Braseth 42nd

Early Design Guidance #2 Meeting
4532 42nd Avenue SW, Seattle WA
DPD #3019962

Introduction

Option 1

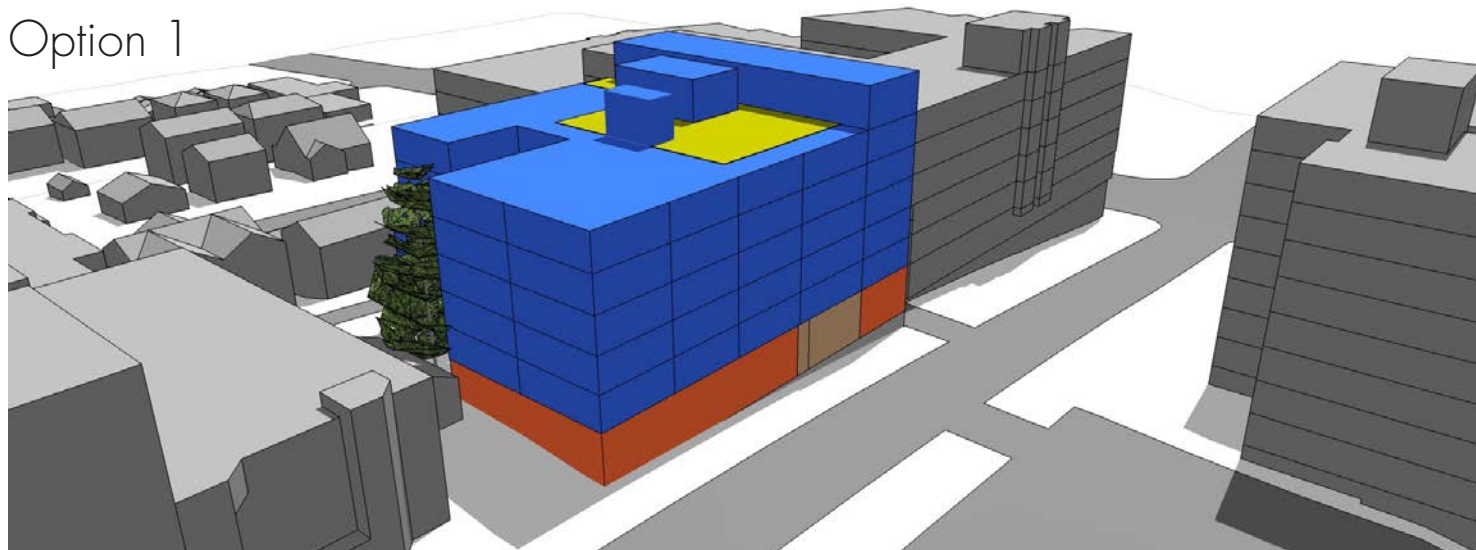
- Option 1 preserved the tree and provided the required rear setback along the alley
- Provide open space on the north side of the site to help activate and enrich pedestrian experience along 42nd Ave.
- Inclined to consider departure for rear setback if tree preserved, modulation relief and attention to open spaces at east

Option 2

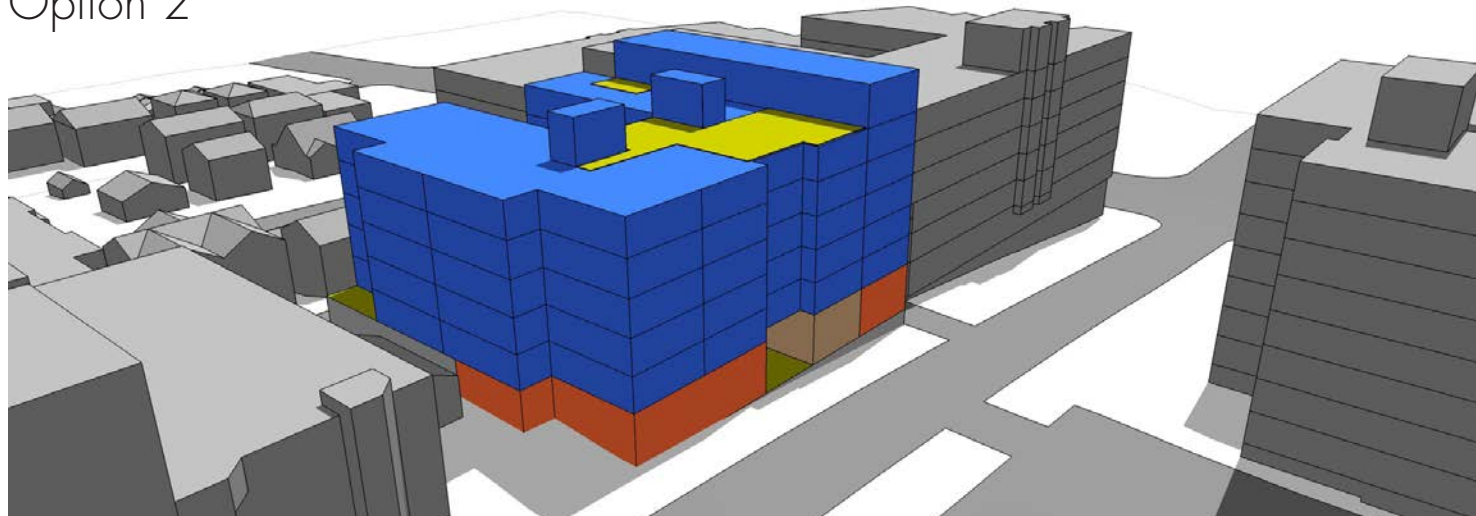
- Alley-facing courtyard well perceived and welcomed relief to the Lowrise zone across alley to the east
- Appreciated notches at the NE and NW corners minimized bulk impacts on the structure to north
- Suggestion that proposed open spaces and modulation be integrated towards north and eastern edges

Option 3

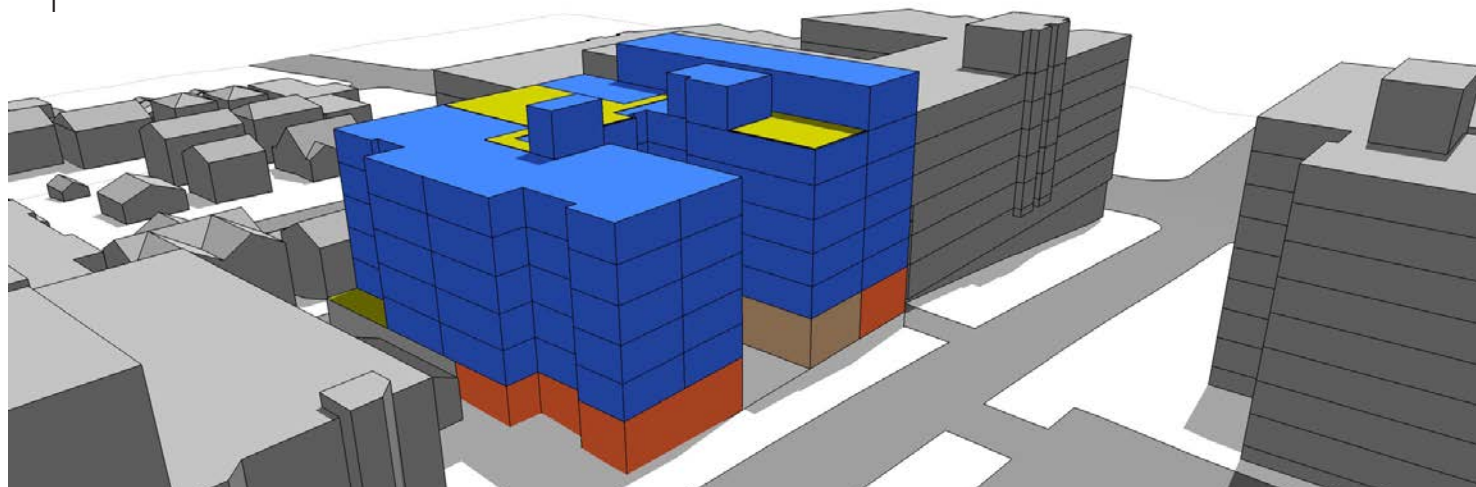
- Appreciated notches at the NE and NW corners minimized bulk impacts on the structure to north
- Enhanced massing solution with main landscaped open space facing the street with direction connection to pedestrian environment
- Break in the street wall facade adds visual interest to 42nd Ave. SW
- Supportive to reinforce positive aspects of the urban street wall in relation to nearby Oregon 42 building
